Llanmaes Flood Alleviation
Scheme Flood
Consequence Assessment
Addendum Technical Note

18 February 2022

Vale of Glamorgan Council

Figure 3-6: Maximum Depth Difference – Frampton Ponds Sensitivity, 100% Capacity, 1.33% AEP

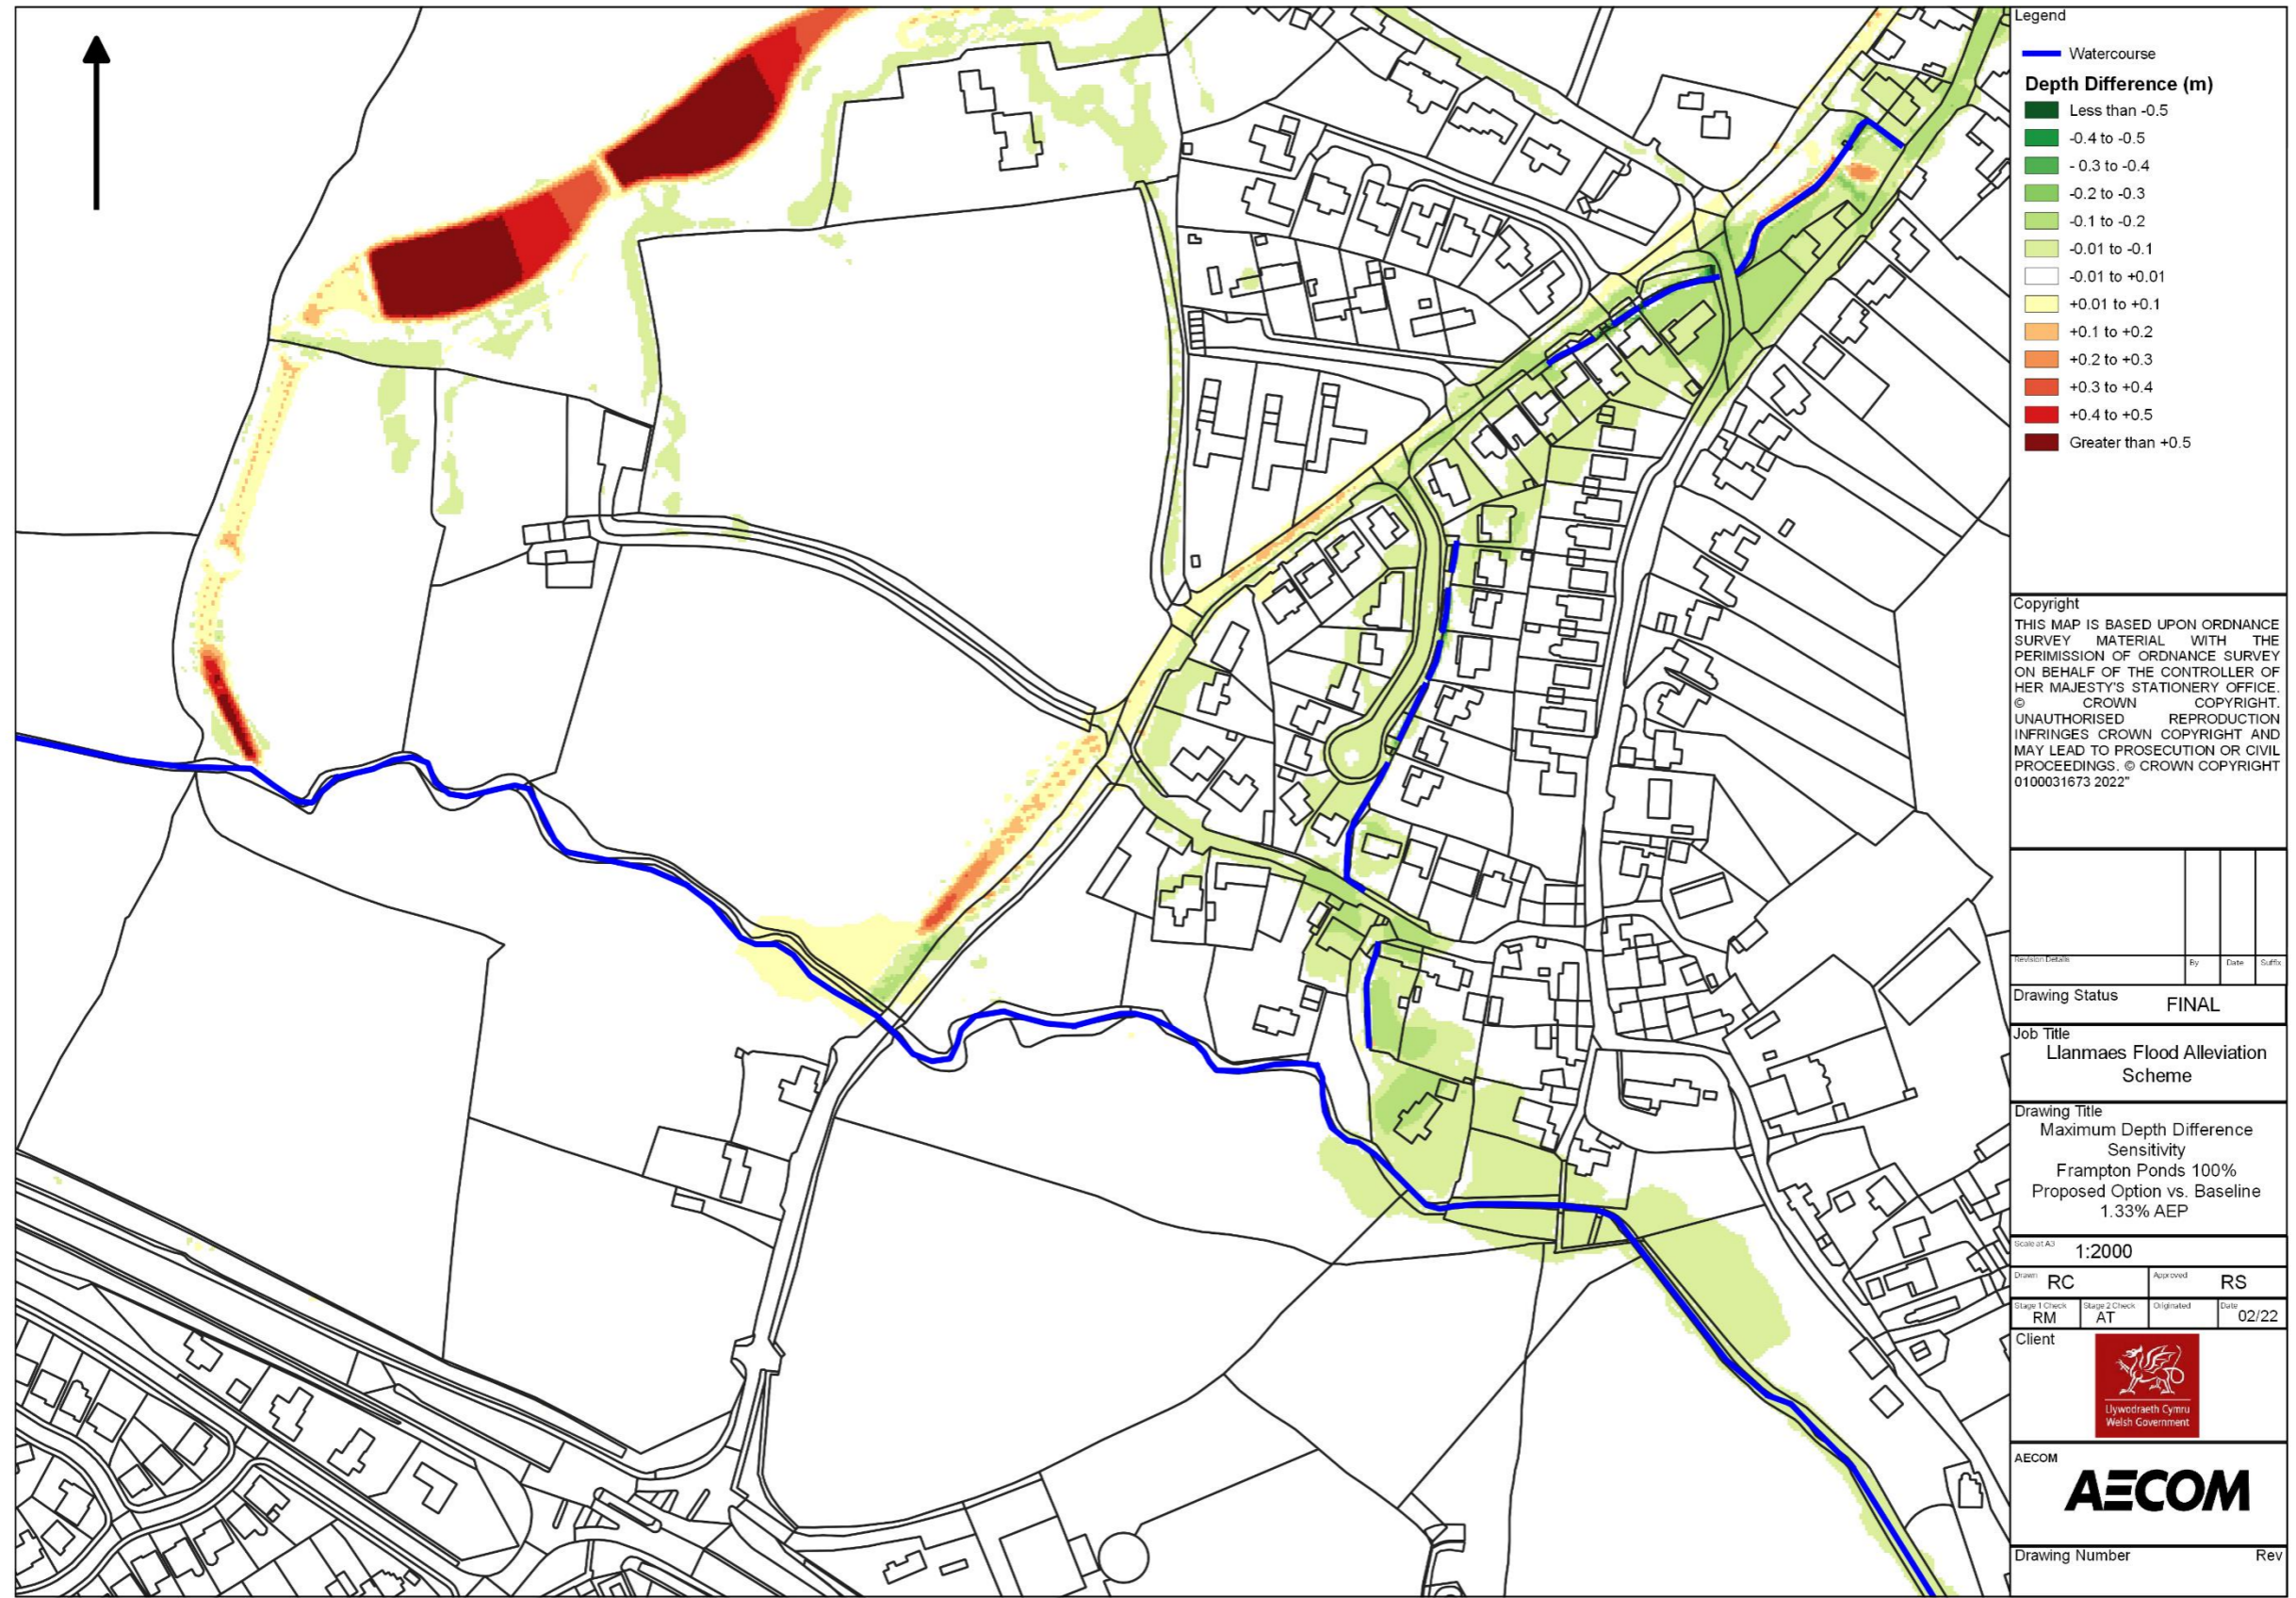
The maximum depth difference plot for Llanames, comparing the Baseline and Proposed Option for the 50% and 100% capacity sensitivity simulations, are shown in Figure 3-5 and Figure 3-6 respectively. There remains an overall reduction in maximum flood depths through Llanmaes with the areas of increased maximum flood depths on Llanames Brook remaining consistent with the results in the design event (Appendix F5). This demonstrates that the proposed scheme functions well under different antecedent conditions and the conclusions of the FCA are still valid.
